**Service Bulletin**

**No. :** MZ07-012

**Model:** SR4001

**Subject:** Software Update Information.

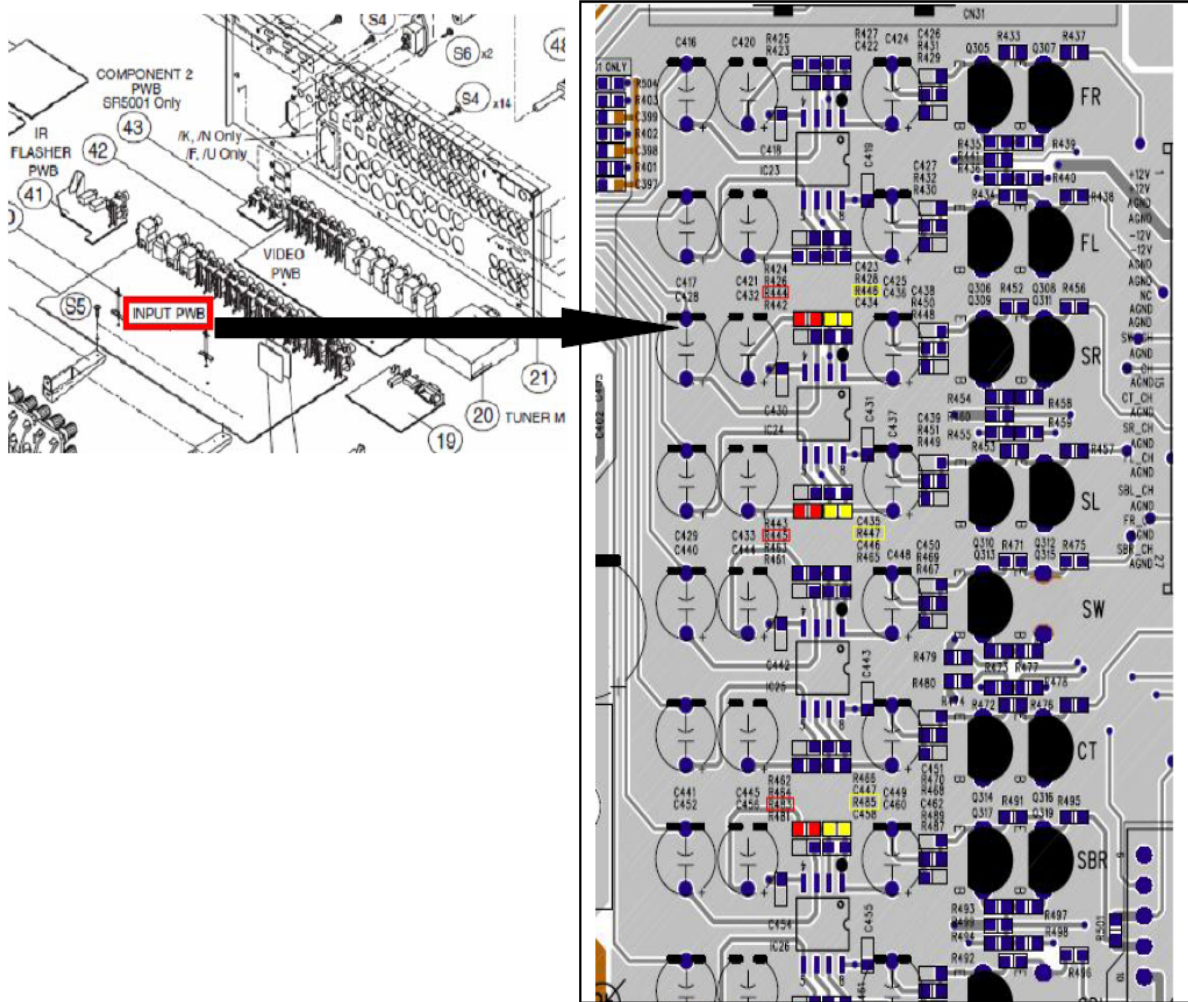
The following serial numbers need fixed resistor values changed. Please make sure to replace the resistors when performing the update.

Input PWB	
R444 / R445 / R483 / R484	8.2K → 4.7K (00MNN05472610)
R446 / R447 / R485 / R486	15K → 4.7K (00MNN05472610)
